## COSMEC GUIDED EXPANSION POT BEARING

STATE OF VERMONT
AGENCY OF TRANSPORTATION

EAST ROAD OVER
VT ROUTE 279
TOWN OF BENNINGTON
BRIDGE NO. B11
PROJECT NO. AC NH 019-1(53)

COSMEC POT BEARINGS

PLAN VIEW

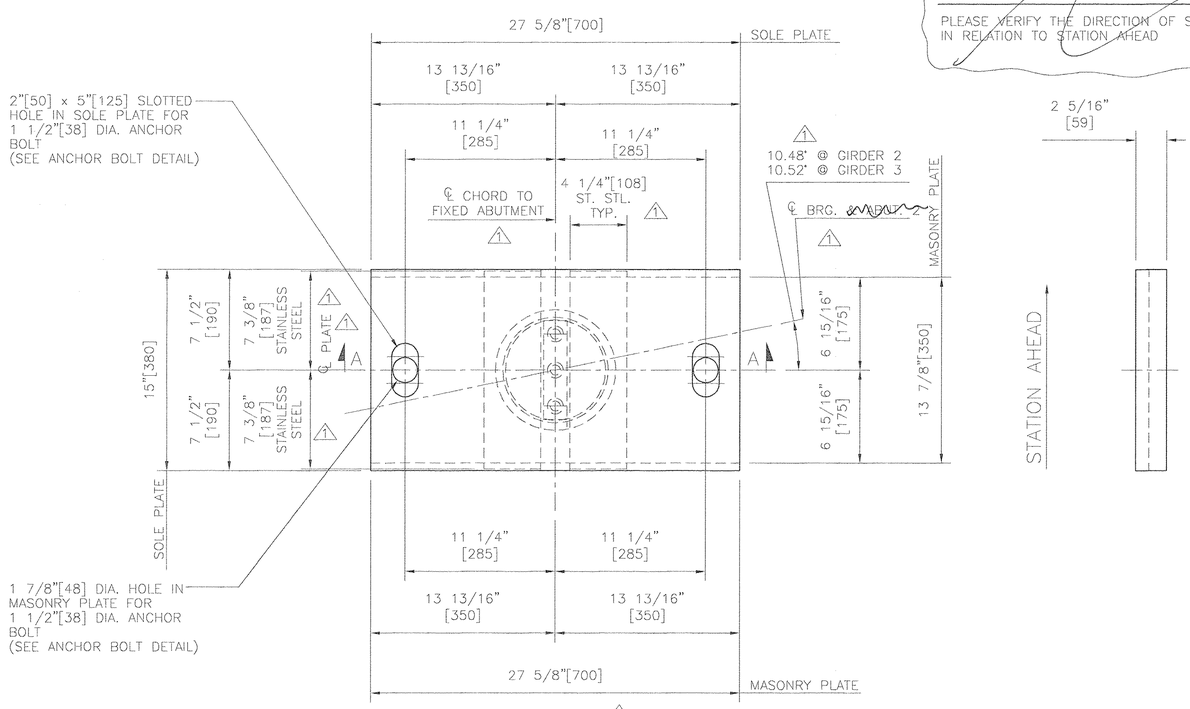
PLEASE VERIFY THE DIRECTION OF SKEWED SLOTS IN RELATION TO STATION AHEAD

KEYWAY DETAIL

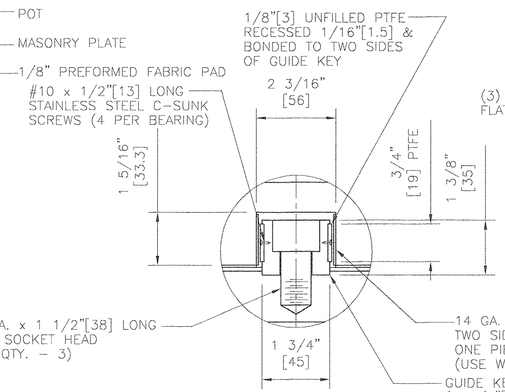
| REV. | | BY | DATE | CK'D | DATE |
|---|---|---|---|---|---|
| 1 | MADE KEYWAY PARALLEL TO GIRDER CENTER-LINE & SHOWED LIMITS OF ST. STL. & AS NOTED PER APPROVERS COMMENTS | MCM | 2/14/08 | MCM | 2/14/08 |
